**BROOKLYN 1B**  
1309 NE 66TH ST

DESIGN REVIEW RECOMMENDATION  
25 JUNE 2018  
DPD #3026788

ADDRESS: 1309 NE 66TH ST  
PROJECT #: 3026788

PROPOSED STREETScape - VIEW FROM THE NORTHWEST

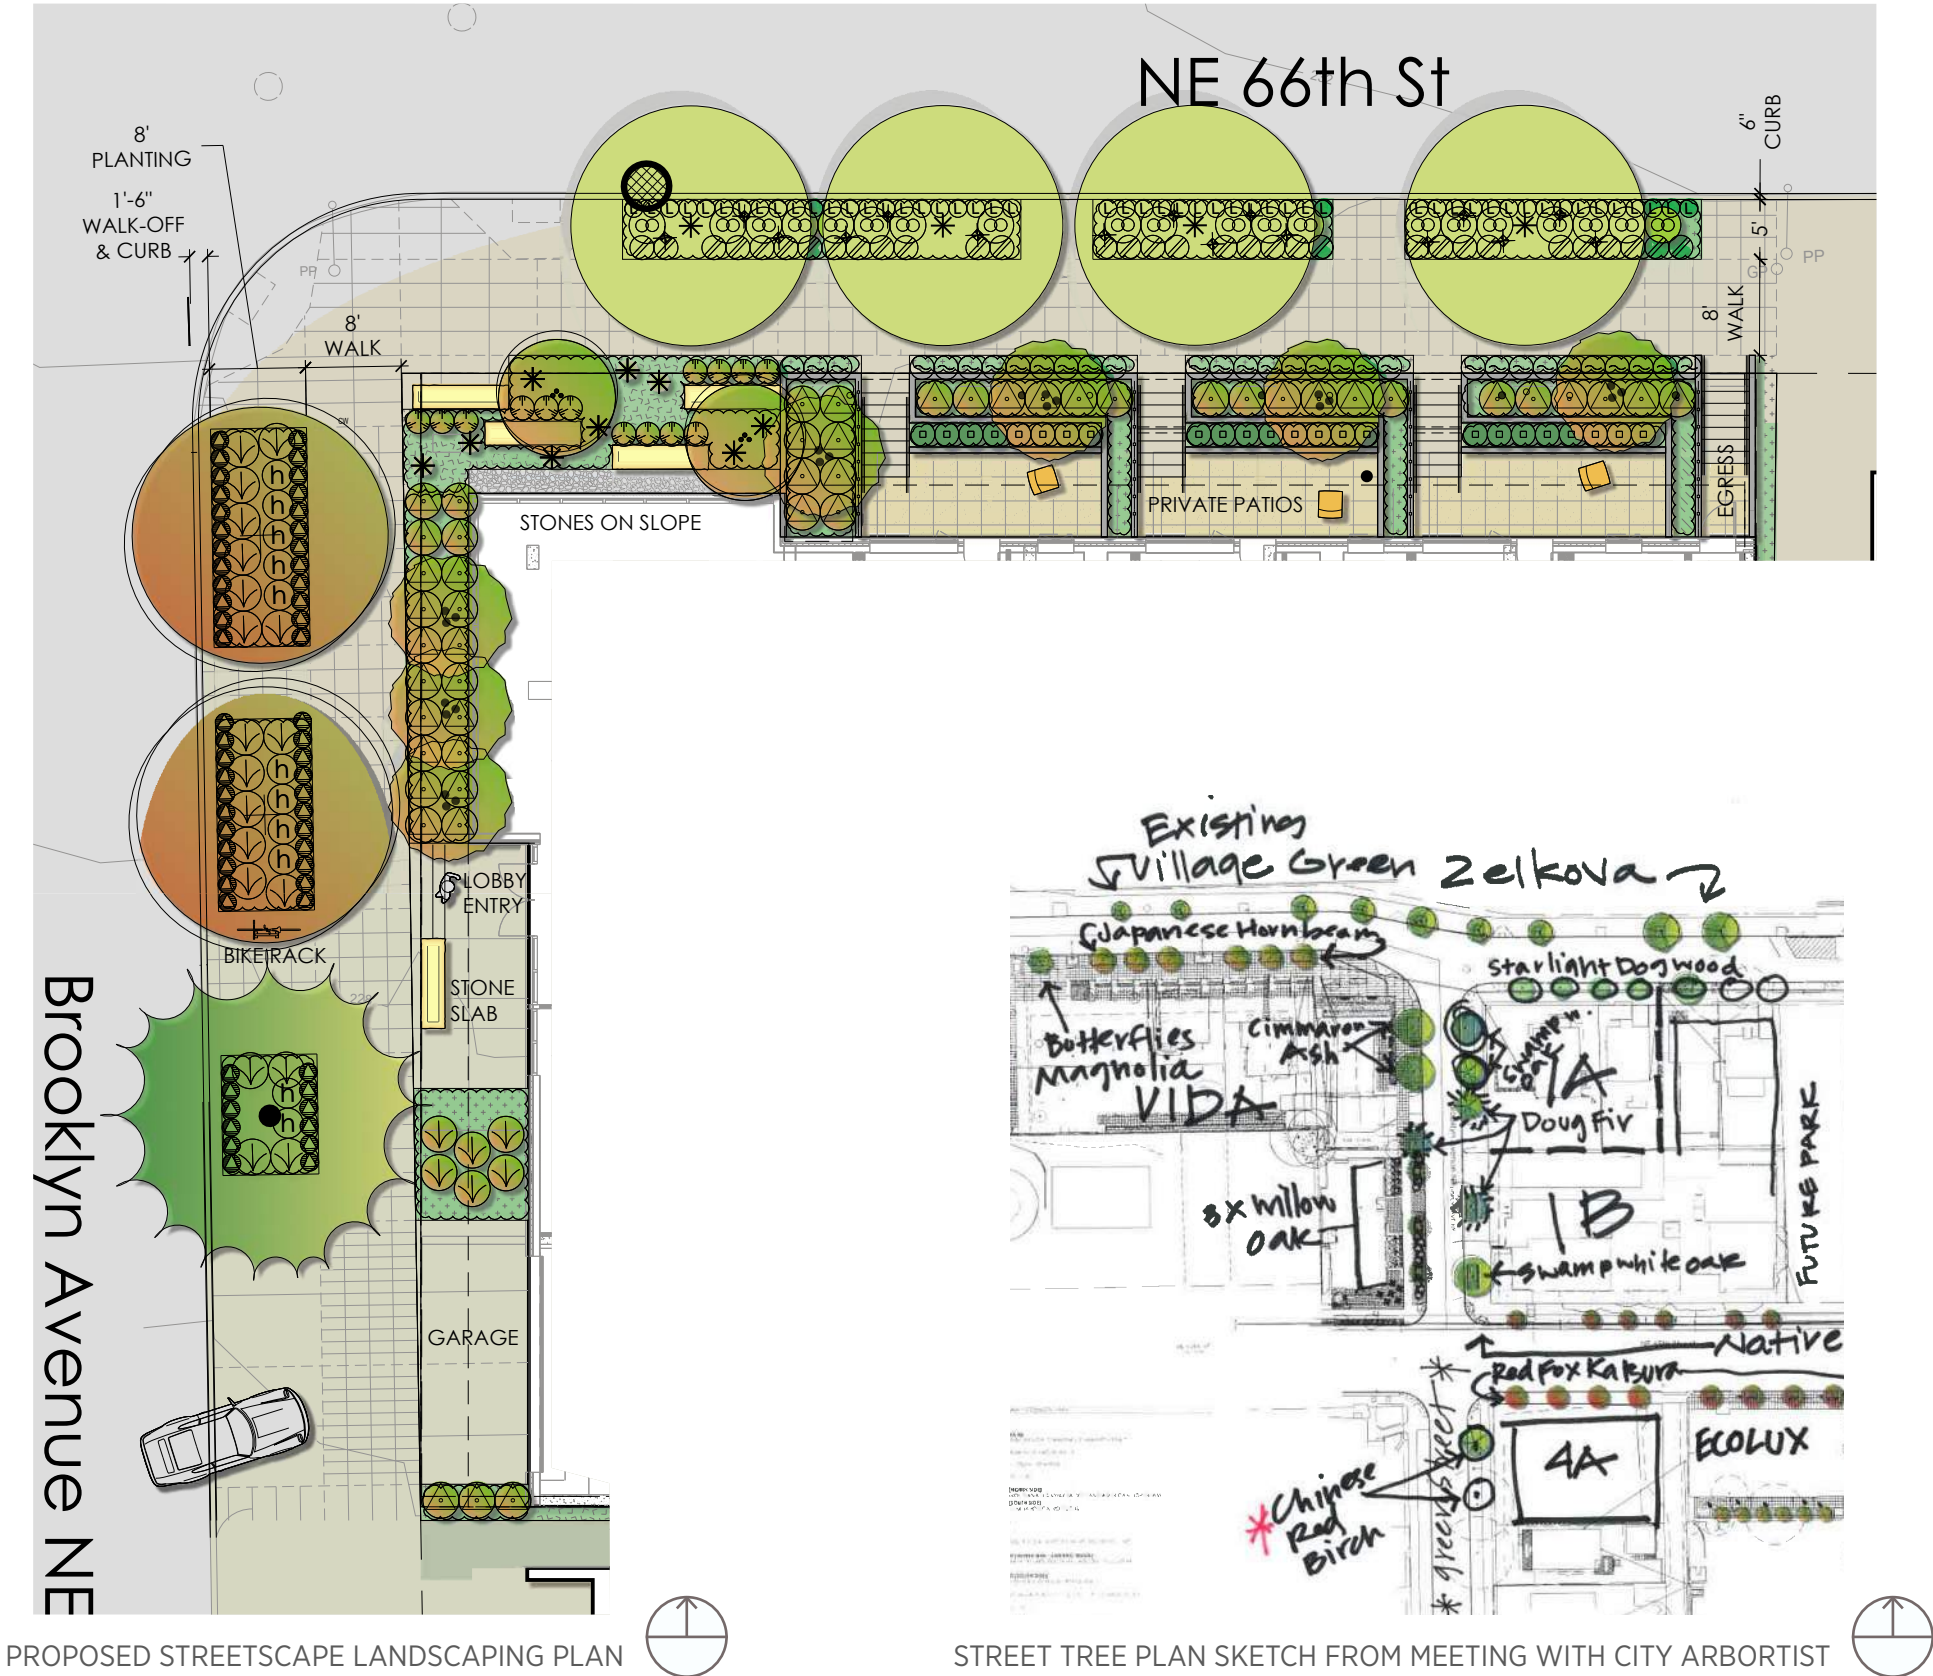
The Board questioned the use of the Douglas fir as a street tree as they are normally forest trees. In light of approval by the City’s arborist and public comment, the Board could support this selection if the composition and relationship to the project design was well conceived.

- a. The Board suggested that the applicant provide an arborist report done to assess the current disposition of the existing street trees.

Updated renderings are provided to show the composition and relationship of the douglas fir to the project. The placement of the douglas fir will help define the outdoor room at the building entry and aligns with the neighborhood street tree plan. An arborist report summary is included in section 10 Landscape/Hardscape Plan.

PROPOSED CORNER

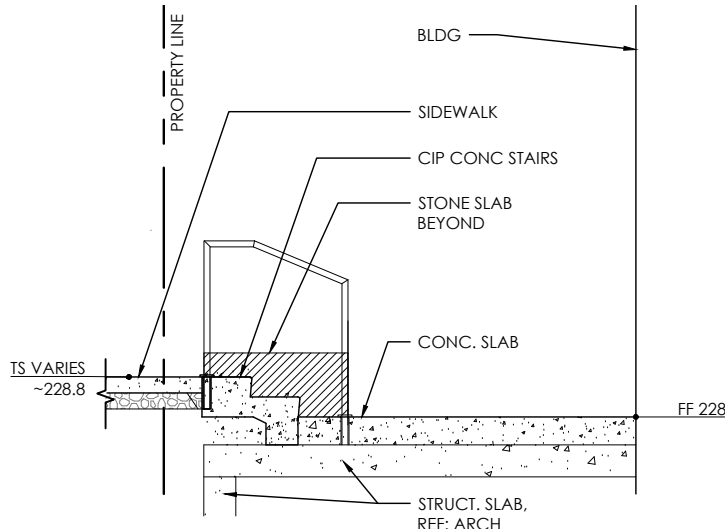
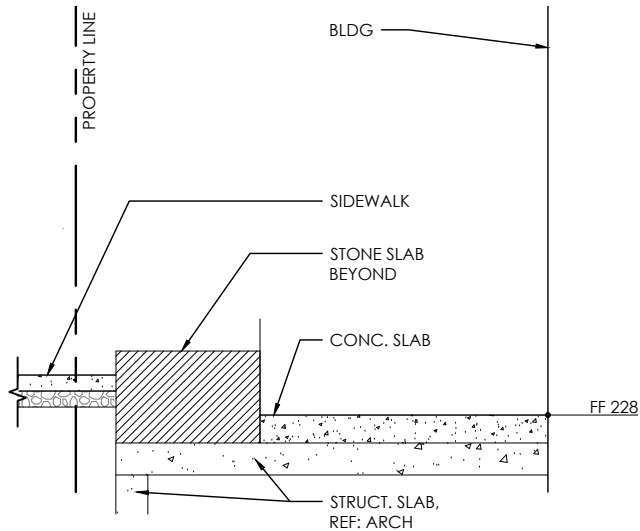
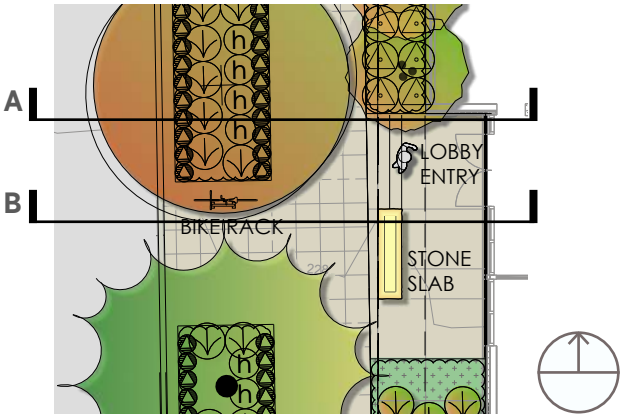
Board members were concerned about the lack of a distinct building entrance at the corner of the preferred option but were satisfied with how the mid-block entry along Brooklyn Ave. leads directly into the lobby area defined by the large two-story transparent façade, located at the corner and in effect announcing the primary entry into the building.

The building entrance is located on Brooklyn Ave NE to align with existing grades and to allow for an outdoor room adjacent douglas fir tree. The building is setback from the northwest corner of the site to provide additional space for pedestrians as well as a public seating bench. Storefront glazing allows views into the 2 story residential lobby space accessed directly from the building entrance located on Brooklyn Ave NE. See updated images.

17.0 DEPARTURE #1

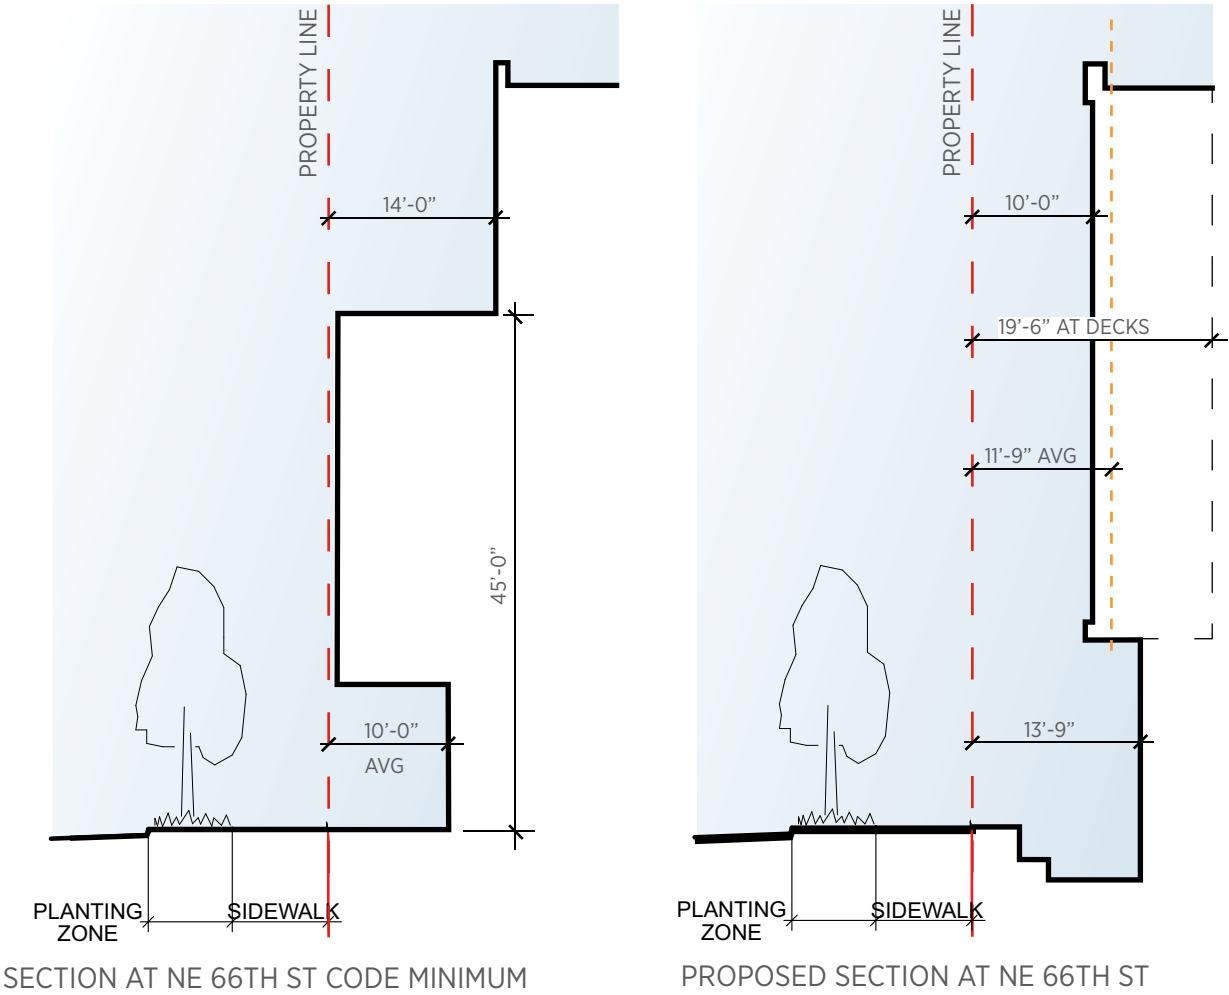
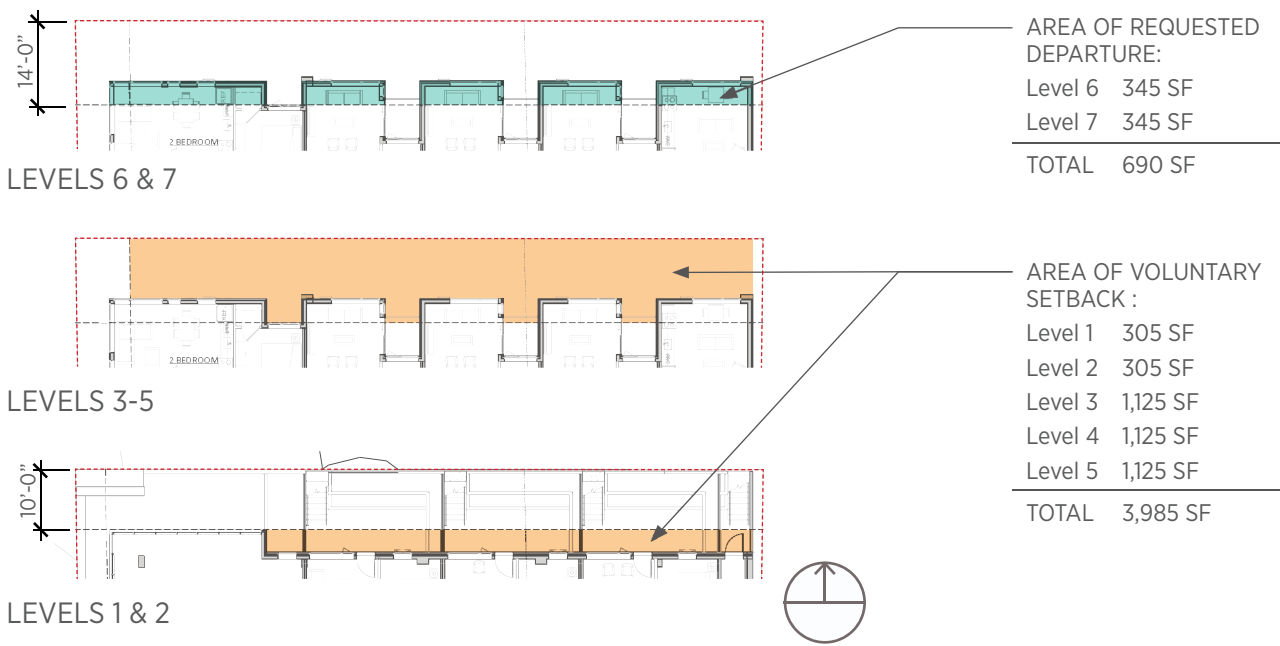
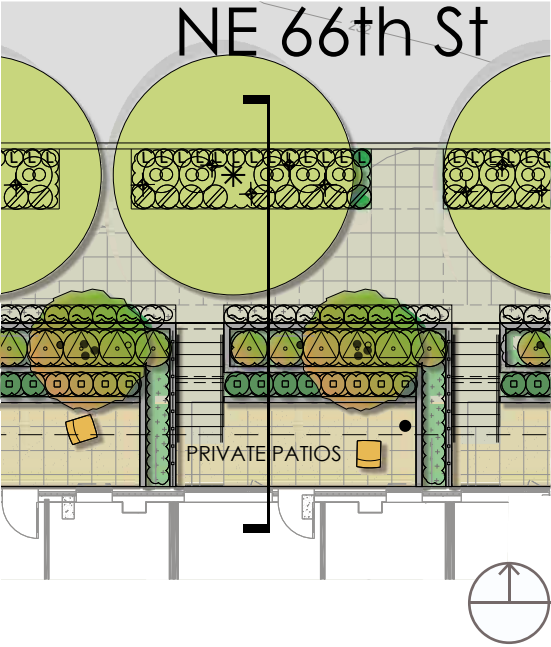
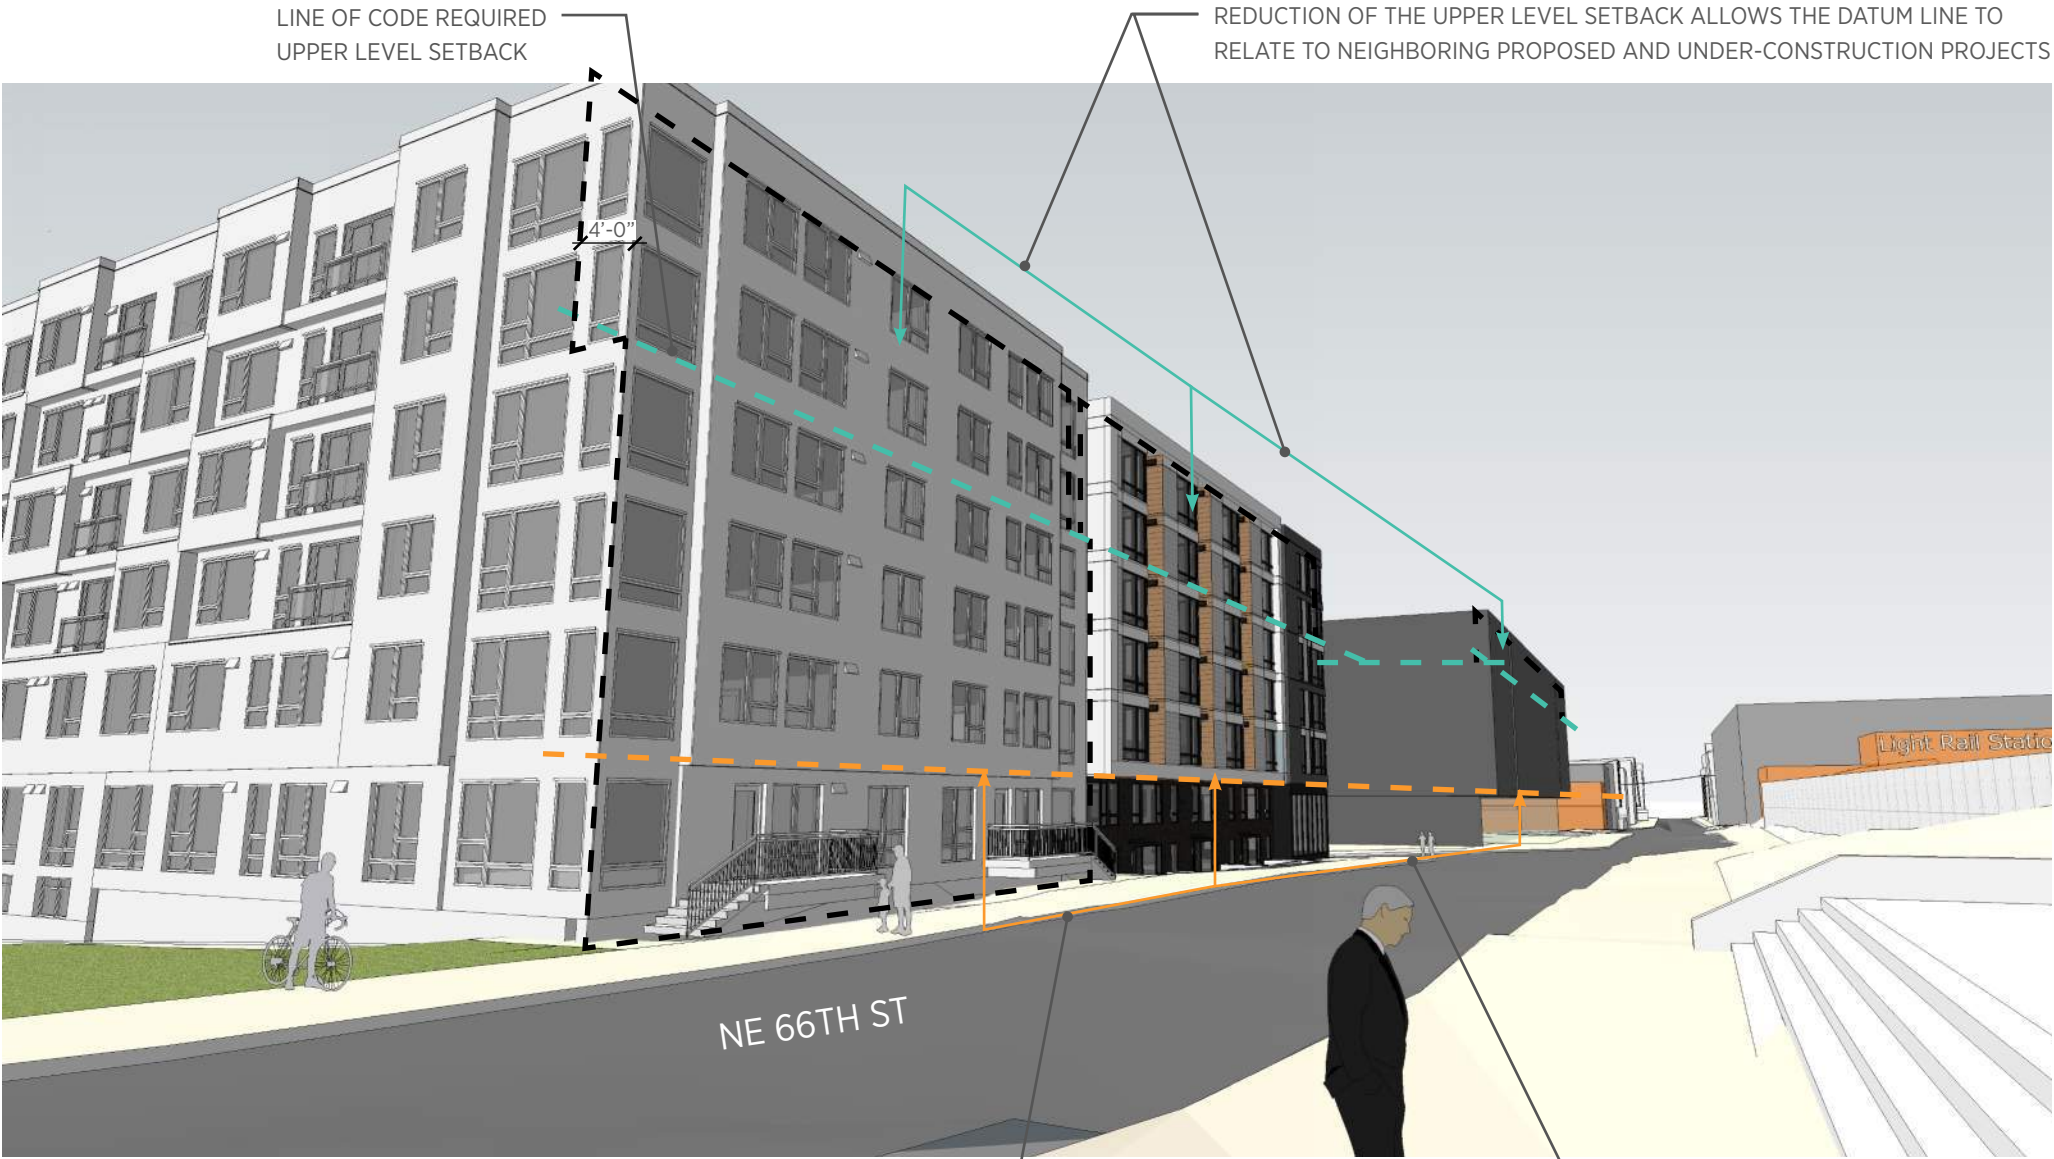
The Board indicated preliminary support for this departure request provided the street level experience is truly enhanced by the highlighted pedestrian amenities and high quality landscape design.

Departure from the 4-foot upper level setback and provide an additional setback at the street level and second level instead. The proposed upper level is setback an average of 11'-9" from the property line and the proposed ground-level setback is 13'-9" from the property line.

The departure would allow for more ability to enhance the pedestrian environment along NE 66th St by providing additional space for improvements, including space for street trees, pedestrian seating, and residential unit yards. The departure will better allow the proposed building massing to relate to neighboring proposed and under-construction projects. The code required setback provides imperceptible shading relief on Roosevelt High School and the associated athletic fields.
